HISTORIC AND DESIGN REVIEW COMMISSION

HDRC CASE NO: 2018-503
ADDRESS: 112 LINDELL PLACE
LEGAL DESCRIPTION: NCB 6204 BLK 5 LOT 1
ZONING: MF-33, H, RIO-1
CITY COUNCIL DIST.: 1
DISTRICT: River Road Historic District
APPLICANT: Jim Bailey/Alamo Architects
OWNER: Asher Reilly
TYPE OF WORK: Amendments to a previously approved site plan regarding the driveway
APPLICATION RECEIVED: September 28, 2018
60-DAY REVIEW: November 27, 2018
REQUEST:

112 Lindell Proposed Amendment to the Certificate of Appropriateness

HDRC APPROVED CONCEPTUAL LANDSCAPE PLAN

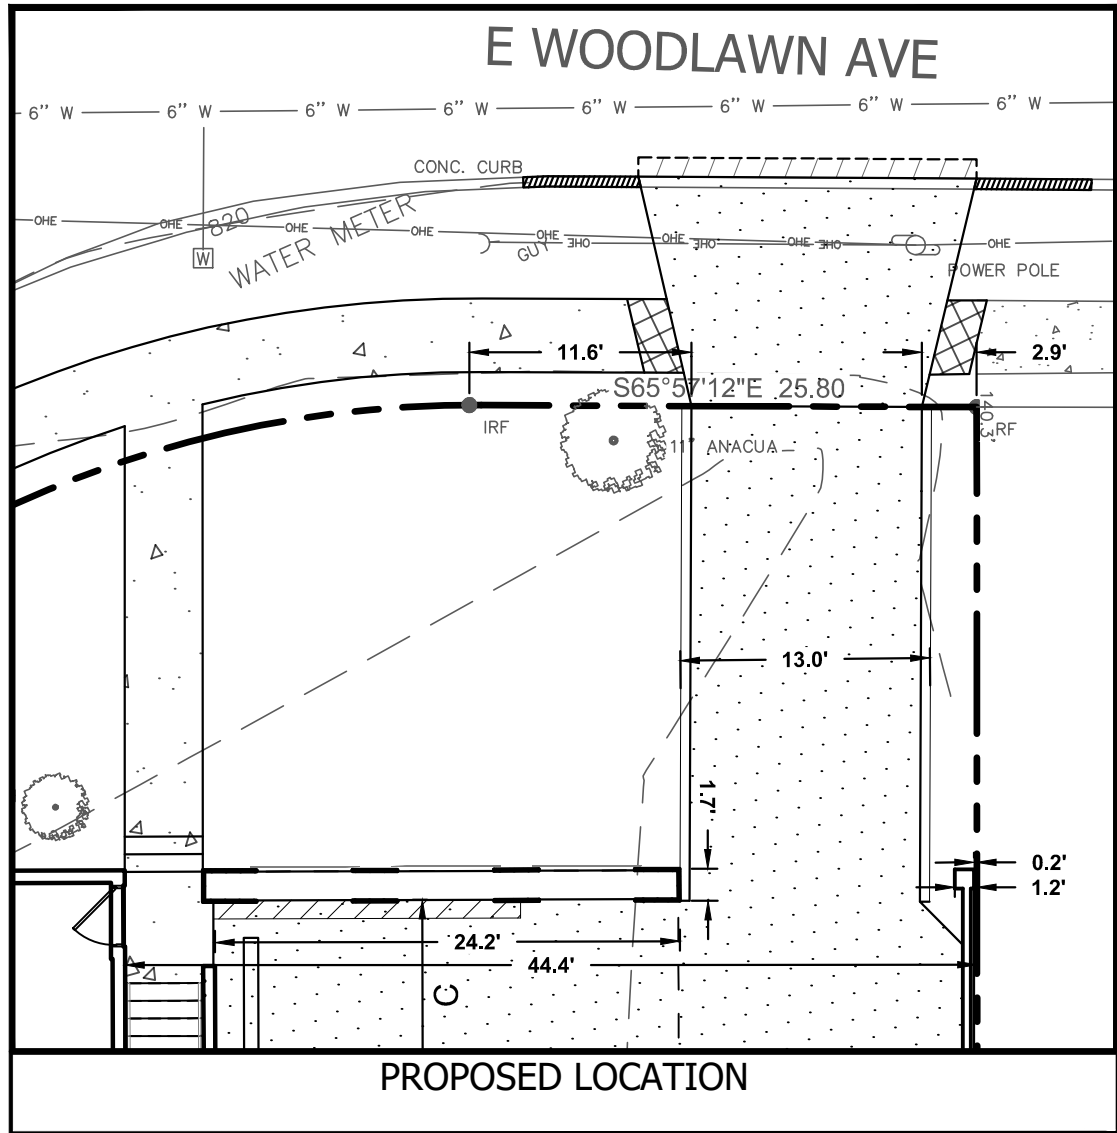
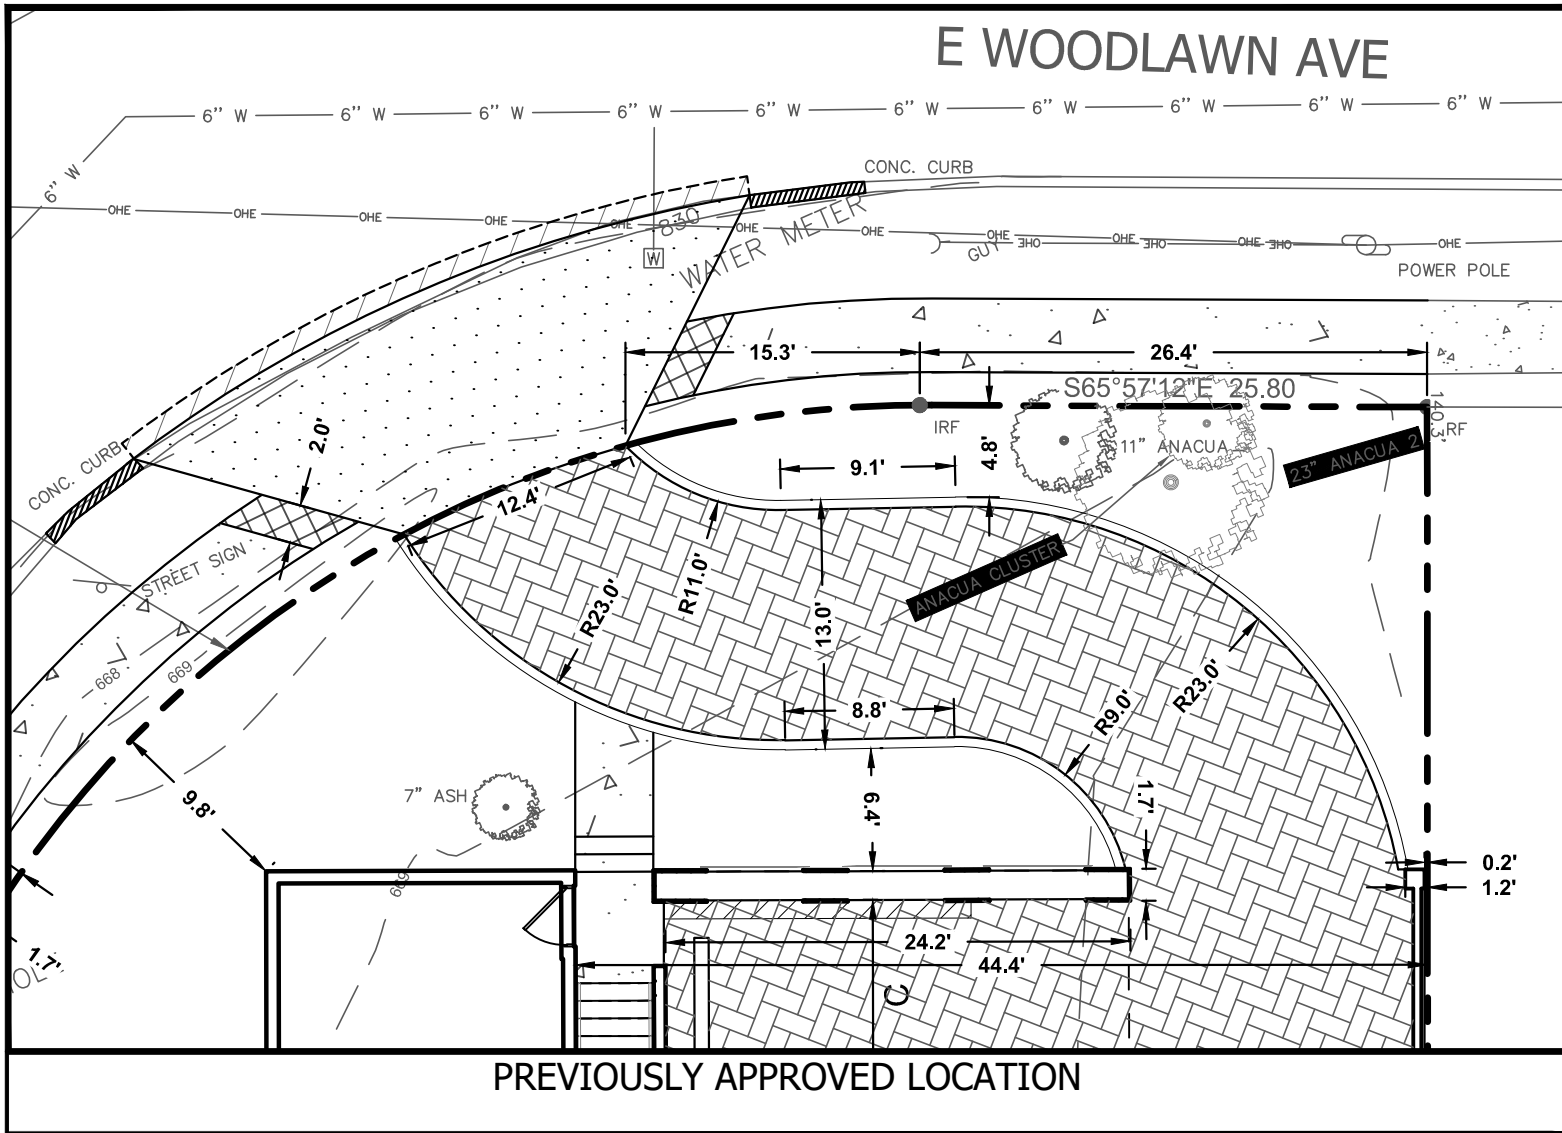
On November 18, 2015, HDRC Case No. 2015-042 received approval for new construction of a two-story building housing six residential units and rehabilitation of the existing structure at 112 Lindell Place, HDRC Case No. 2015-042. The current request is specific to the relocation, revised geometry and revised material proposed for the portion of the driveway accessed from E. Woodlawn Ave.

- A. Straighten the driveway and relocate the curb cut/access from Woodlawn to the eastern edge of the property.
 - a. Safer traffic conditions are achieved by moving away from intersection and simplifying the vehicle maneuvering required.
 - b. Reduces the amount hardscape and allows for more landscaped area, which promotes a better overall aesthetic.
- B. Driveway to be concrete in lieu of pavers.
 - a. Due to the health/removal of the anacua tree, pervious pavers are no longer critical to its sustainability.
 - b. Uniformity with neighboring driveways consisting of concrete.

Staff recommends approval based on finding a through d with the stipulation that the applicant install a driveway that features a width that is comparable to those found historically on E Woodlawn and that a tree be planted to mitigate the removal of the anacua.

TREE PRESERVATION & PERMIT REQUIREMENTS

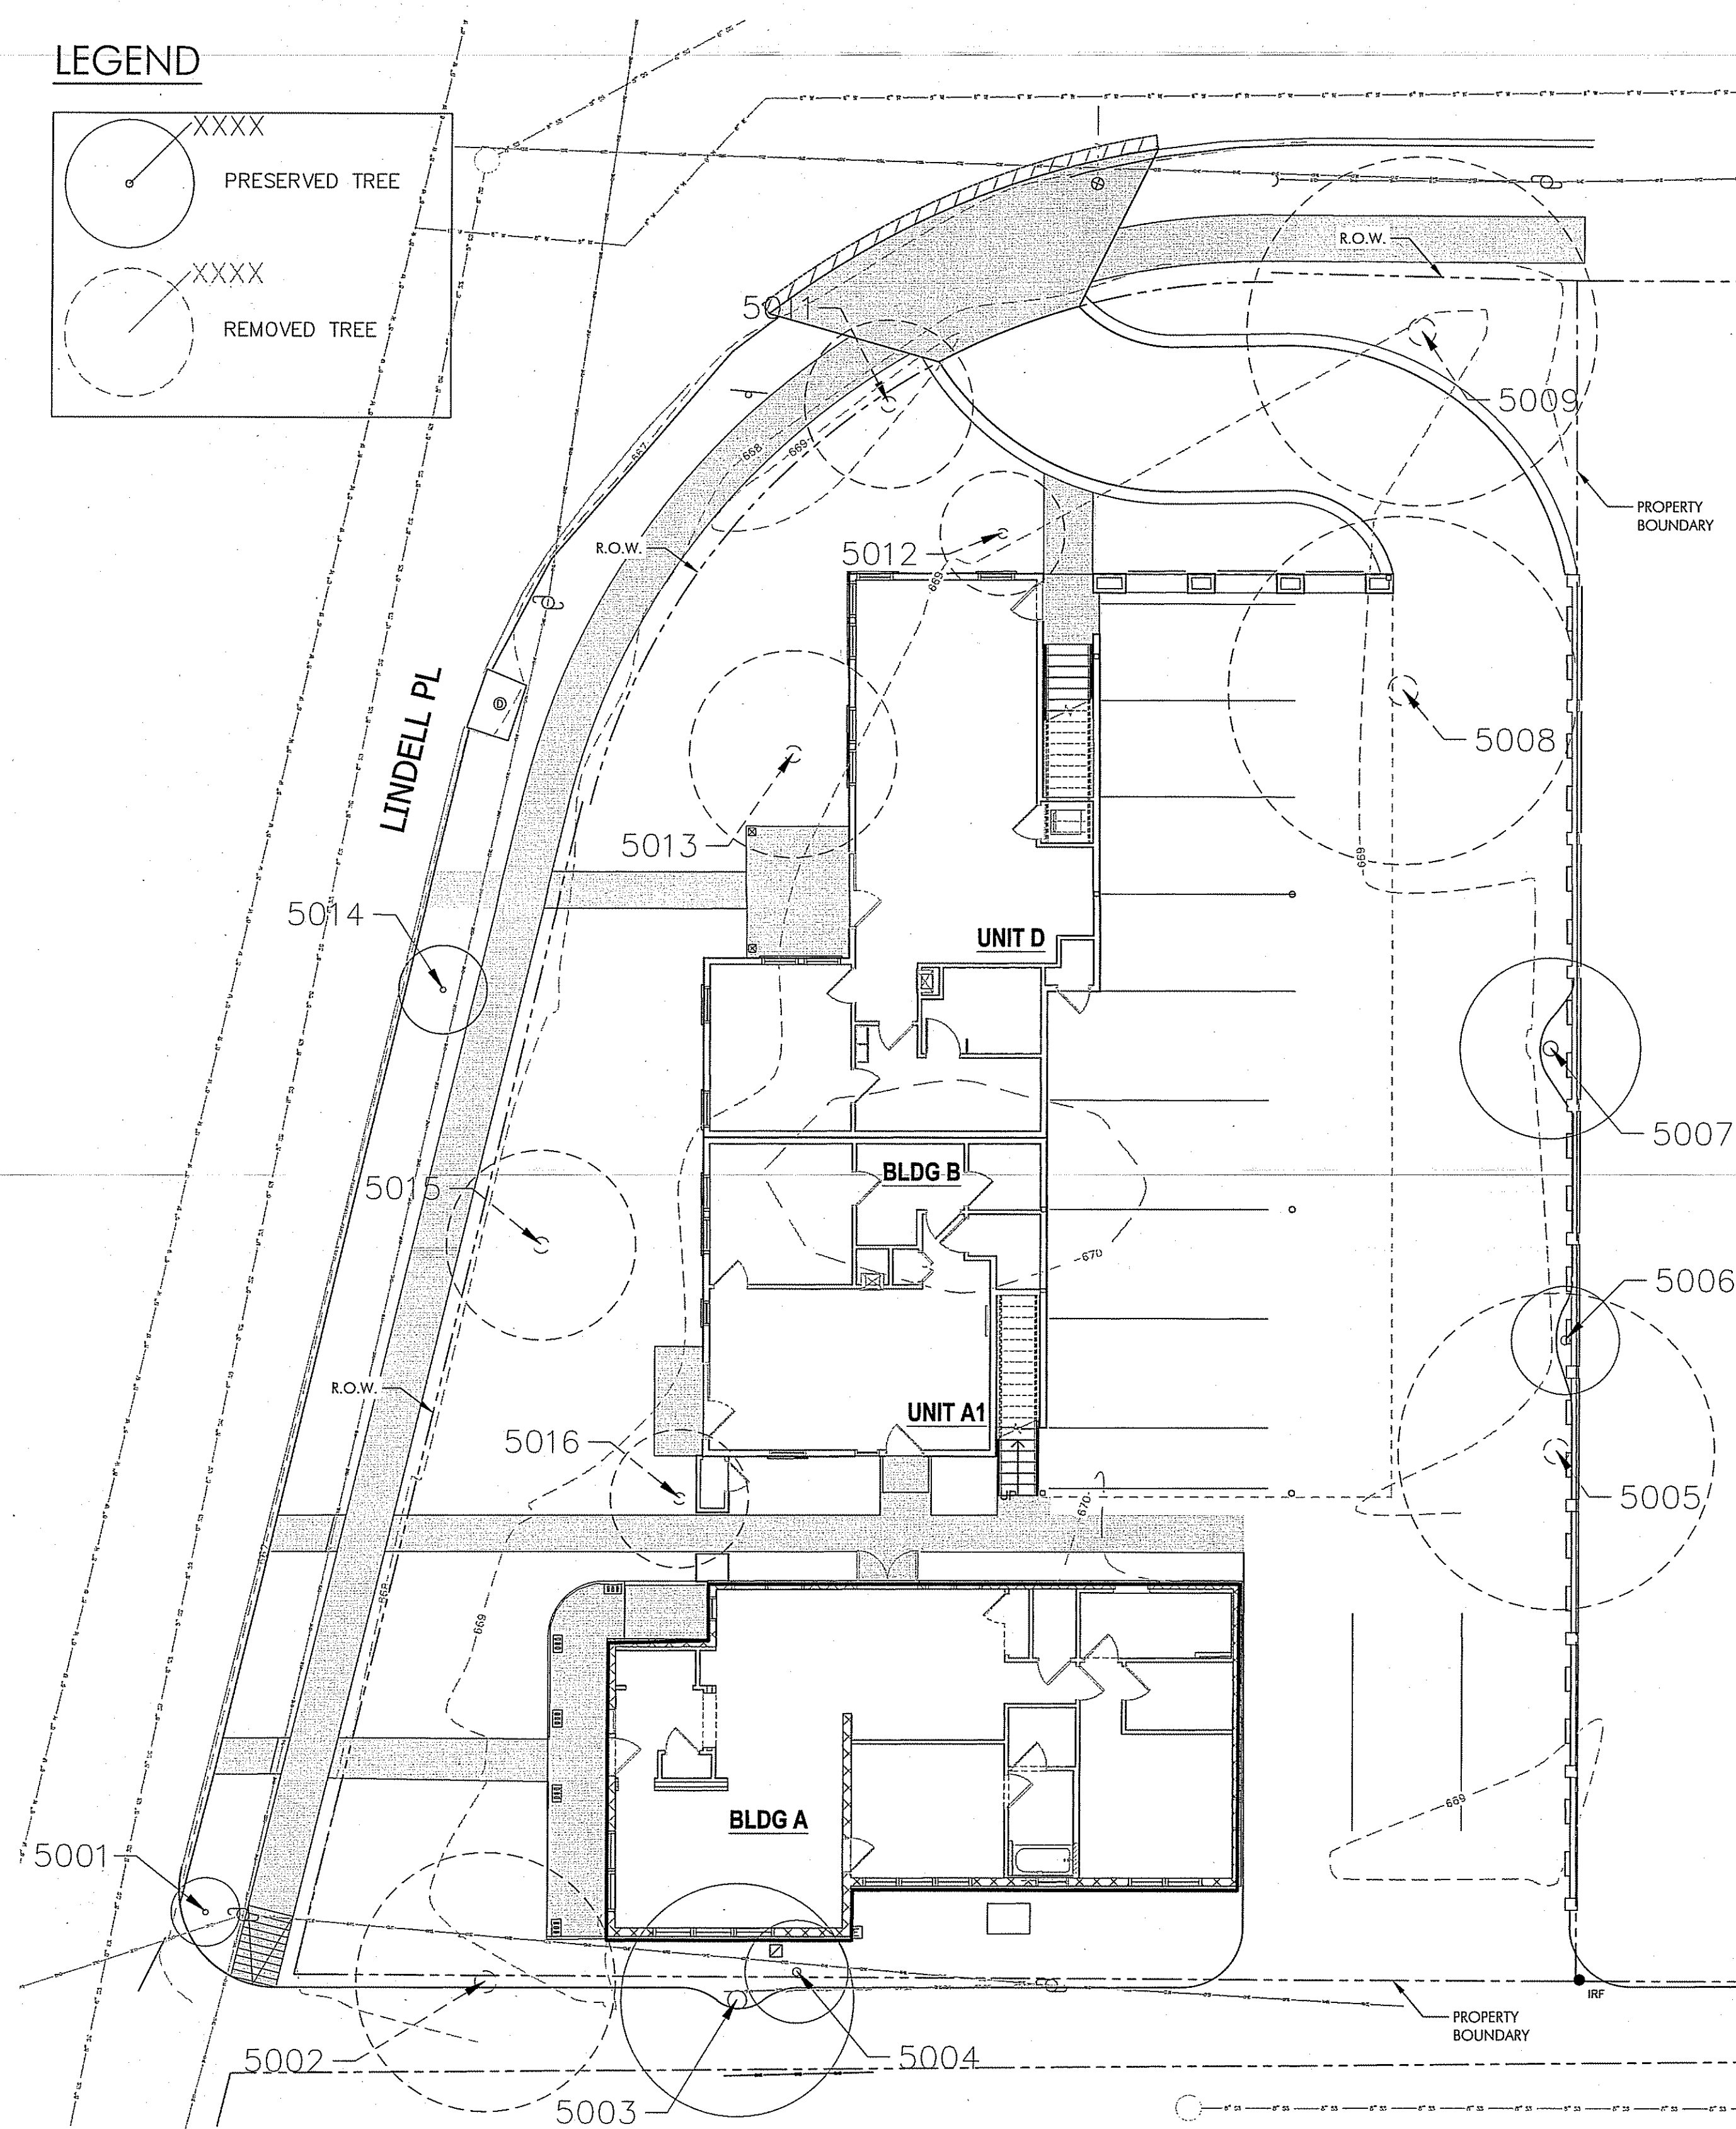
Insp Type:	Request Date:	Insp Date:	Insp Status:	Inspector Name:	Insp Comments:
TREE FINAL			NO ACTION	ADRIANA GOETZ	
TREE PRELIMINARY	12/18/2017 8:40:00 AM	12/18/2017 10:50:00 AM	PASSED	STEVEN DENNIS	LARGE ANAQUA IS IN DECLINE 10 % OF TREE ALIVE. UNKNOWN TREES MARKED ON PLAN. LARGE CRP MYR MAY NOT BE SAVED IF GRADE CHANGE WITHIN RPZ
